KIT 10045 ϕ

PSP-500		A10401	2 FEB 72
MODEL	PROJECT NO.	ASS'Y. NO.	DATE

STOCK SIZE		TMC (Canada) LIMITED OTTAWA ONTARIO	
MATERIAL		RECTIFIER HIGH VOLTAGE MOD KIT	
TYPE & TEMPER		L. BROWN	
HEAT TREAT. SPEC.		PROCTOR	
FINISH & SPEC. NO.		KIT 10045 ϕ

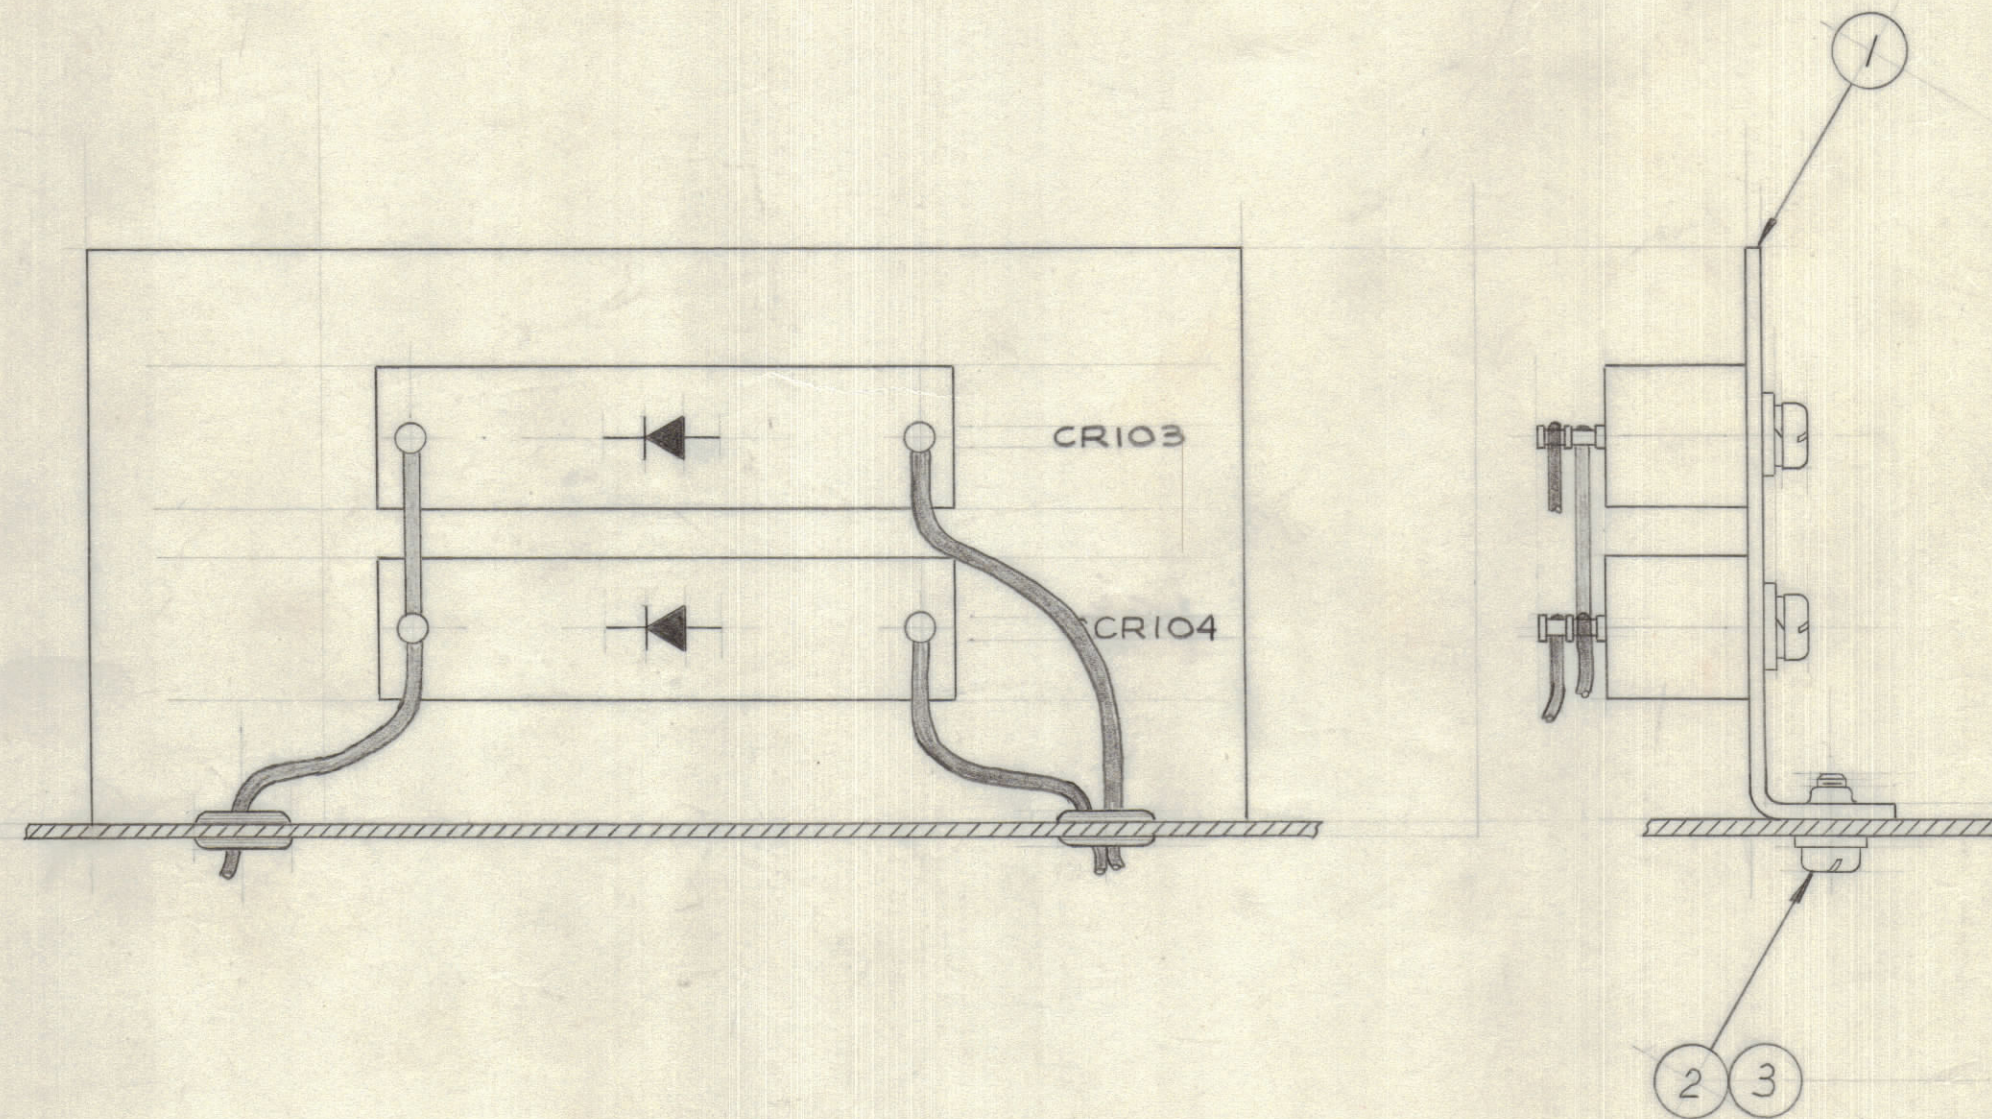
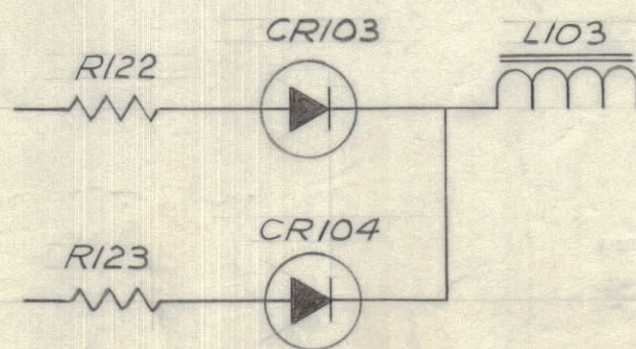
REPLACE PRESENT RECTIFIER BRACKET ASSEMBLY WITH ITEM 1 AND SECURE WITH ITEMS 2 & 3 CHANGE WIRING AS PER SCHEMATIC DIAGRAM SHOWN BELOW
